MEMORANDUM

RE: ZP15-0738CA; 747 Pine Street

Request: Renovation to existing warehouse building; removal of approx. 8,700 building addition, exterior façade upgrade, improved stormwater management, add parking.

South elevation, as proposed

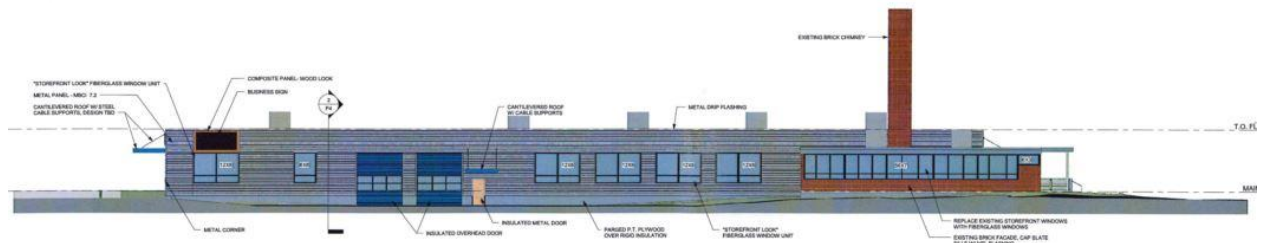
The principle building is proposed to remain, although enjoy new exterior finishes. The larger freezer section is proposed to be removed, thus eliminating the larger element of bulk from the site. **Affirmative finding.**
